Access Compliance Report

Public Rights-of-Way

(Curb Ramps)

Intersection ID: 14225	Main Street: N_CASWELL_RD	Cross Street: VAIL_AV	Location: SE
ADA ID: A69693F8EA7D	Ramp Type: PerpDiag	Initial Pass/Fail: Fail	Overall Compliance: No
			Severity Score: 21.25

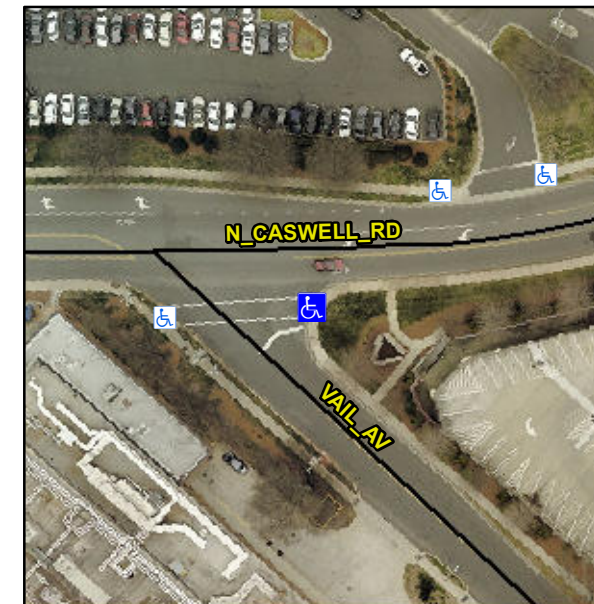
Not Found, R304.5.1, R304.5.3

Compliance	Description	Data	Compliance	Description	Data
N/A	Ramp Length (in)	57.0	Yes	Ramp Slope (%)	6.5
No	Ramp Width (in)	47.0	No	Ramp XSlope (%)	5.3
N/A	Flare Type LT	N/A	N/A	Flare Type RT	N/A
N/A	Flare Slope LT (%)	N/A	N/A	Flare Slope RT (%)	N/A
N/A	Flare Traversable LT?	N/A	N/A	Flare Traversable RT?	N/A
N/A	Landing Length (in)	N/A	N/A	DWS Provided?	N/A
N/A	Landing Width (in)	N/A	N/A	DWS Contrast?	N/A
N/A	Landing Slope (%)	N/A	N/A	DWS Length (in)	N/A
N/A	Landing X Slope (%)	N/A	N/A	DWS Full Width?	N/A
N/A	Landing Curb? (Y/N)	N/A	N/A	DWS Offset (in)	N/A
N/A	Shared Landing?	N/A			
N/A	Gutter Ponding?	N/A	N/A	Gutter Slope (%)	N/A
N/A	Gutter Lip Ht (in)	N/A	N/A	Gutter X Slope (%)	N/A
N/A	Painted X Walk1?	No	N/A	Painted X Walk2?	Yes
	X Walk 1 Direction	To NE		X Walk 2 Direction	To W
N/A	X Walk 1 Width (in)	N/A	N/A	X Walk 2 Width (in)	112.0
	X Walk 1 Slope (%)	2.0		X Walk 2 Slope (%)	2.6
	X Walk 1 X Slope (%)	2.4		X Walk 2 X Slope (%)	3.6

Remove & Replace Curb Ramp With Two New Directional Ramps or Equivalent.
